VILLAGE OF WINDSOR
BOARD RESOLUTION 2018-93

APPROVAL OF THE SITE PLAN REVIEW FOR SUMMIT CREDIT UNION AT LOT 1 OF CSM #14307, IN THE VILLAGE OF WINDSOR

To:	Village of Windsor Board
Cc:	Robert Wipperfurth, Tina Butteris, Christine Capstran, Kevin Richardson, William Cole
From:	Amy Anderson Schweppe, Jamie Rybarczyk
Rpt Date:	September 28, 2018
Mtg Date:	October 4, 2018
Submtl Date:	August 13, 2018
Aprvl Date:	N/A
Re:	Summit Credit Union – Site Plan Review

SHEET NUMBER
C1.0

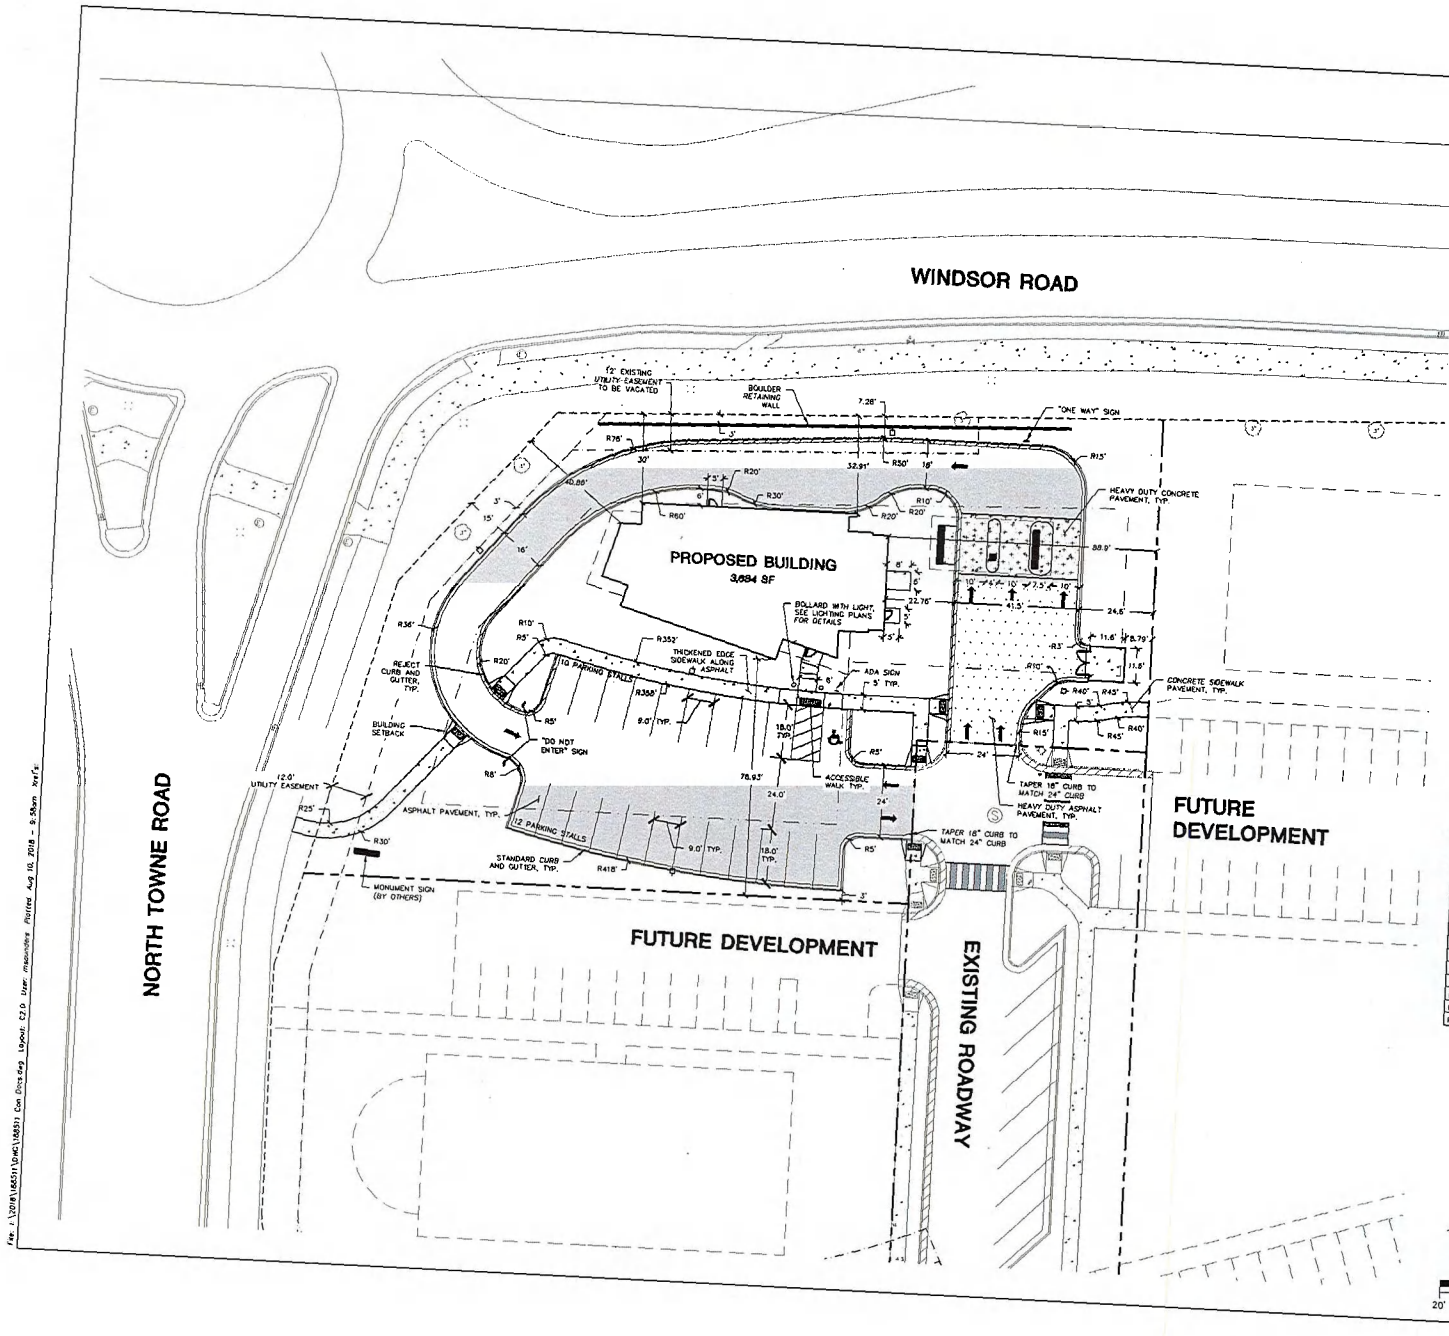
1. *Village of Windsor Code of Ordinances: Chapter 10 Buildings and Building Regulations*
    a. Site design: The Site Plan depicts a centrally located building with circulation and parking surrounding the site. The site makes use of the topography to provide maximum visibility of the building.

b. Circulation and access: The Site Plan depicts a detached teller facility with a circular one-way drive lane that terminates in the general parking lot on the south lot line of the property. Pedestrian access is shown from the multi-purpose path on the west edge of the property that integrates circulation within the lot and terminates inside the development providing links to future development sites.

c. Landscape and buffers: The Site Plan depicts foundation planting masses around the buildings, sign and retaining wall. Perimeter plantings include deciduous and evergreen trees compatible with their location.

The Petitioner is re-engineering the Site Plan to comply with Section 38-579.

SHEET NUMBER
C3.0

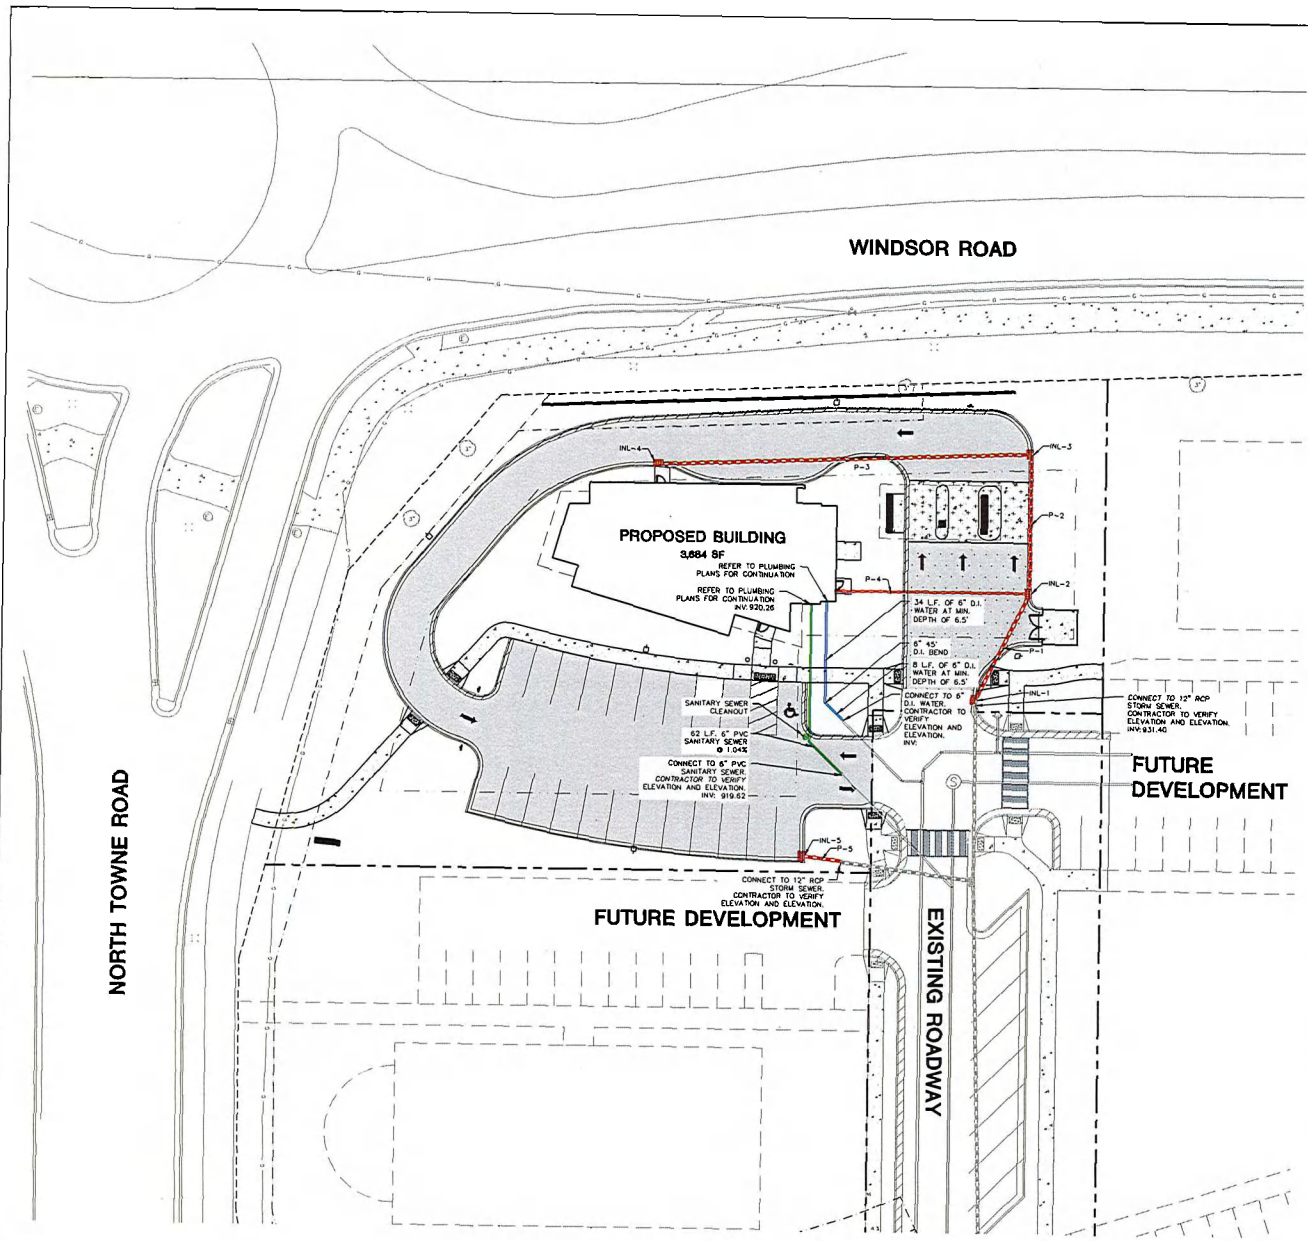
1. The Petitioner shall coordinate with the Utilities Staff to perform fire flow at the connection to the distribution system.
2. The Petitioner shall salvage the existing hydrant at the connection to the distribution system and reuse within the development or deliver to the Windsor Utilities located on Park Street.
3. The Petitioner shall increase the size of the first section of watermain from 8" to 10" between the connection at the 8" stub into the property to where the two 8-inch mains split. The Petitioner shall provide an 8 by 10" increaser at the connection, a 10 by 8" tee, and a 10 by 8" reducer on the 8" line heading east. This is requested to reduce head losses with fire flows above 1,500 gpm, since this will be served by the main pressure zone.
